Economic Commission for Europe**Inland Transport Committee****World Forum for Harmonization of Vehicle Regulations****Working Party on Passive Safety****Fifty-eighth session**

Collective amendments to Regulations Nos. 14 and 16**Proposal for Supplement 7 to the 06 series of amendments to Regulation No. 14 and Supplement 7 to the 06 series of amendments to Regulation No. 16****Submitted by the expert from the Netherlands***

I. Proposal for Supplement 7 to the 06 series of amendments to Regulation No. 14 (Safety belt anchorages)

II. Proposal for Supplement 7 to the 06 series of amendments to Regulation No. 16 (Safety-belts)

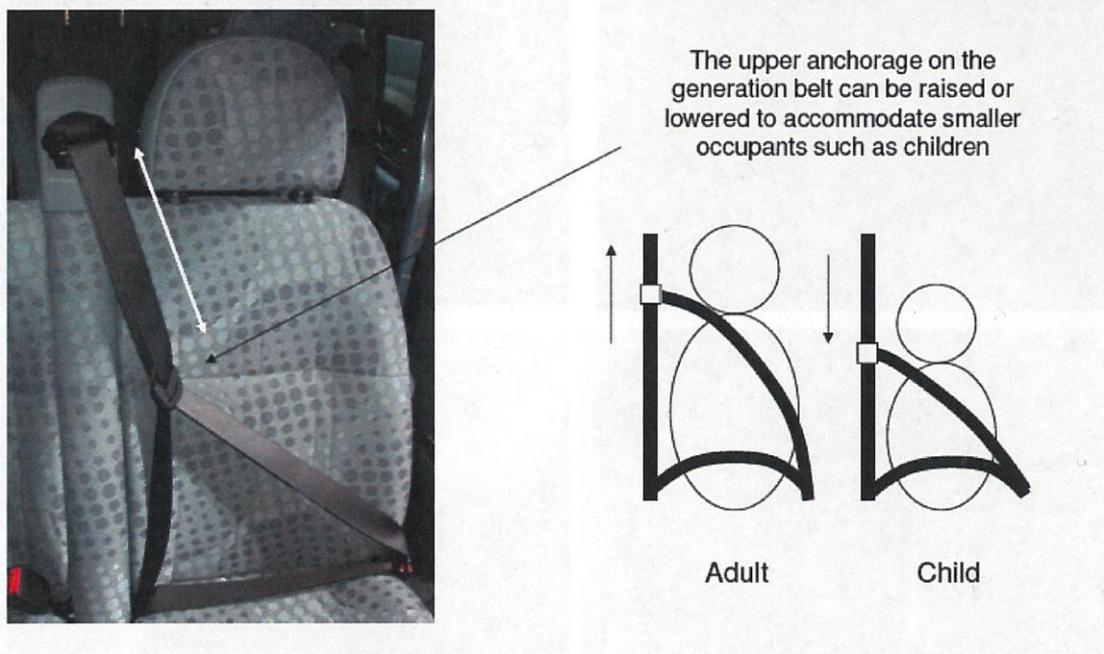
2. The situation explained above has caused confusion so far: a belt/restraint system that makes use of **a flexible shoulder adjustment device for height** (sometimes called **generation belt**, see the explaining figure on next page), does not make use of the upper-pillar loop for adjustment and therefore cannot be mentioned on the Communication form.

4. This proposal introduces a definition for flexible shoulder adjustment device for height. This definition has been further extended to make sure that the adjusting forces may NOT be derived from the lap belt part (examples of options which should not be covered in our definition, because they enlarge the danger of submarining, are given next page). The definition is worded in the positive way, so what is preferred.

5. Moreover, the complexity and sensibility of the flexible adjustment device for height (generation belts) does not justify a dynamic test according to UN Regulation No. 16, which provides a generic stiff seat. A test proposal for a restraint system (in combination with a real vehicle seat) is shown below:
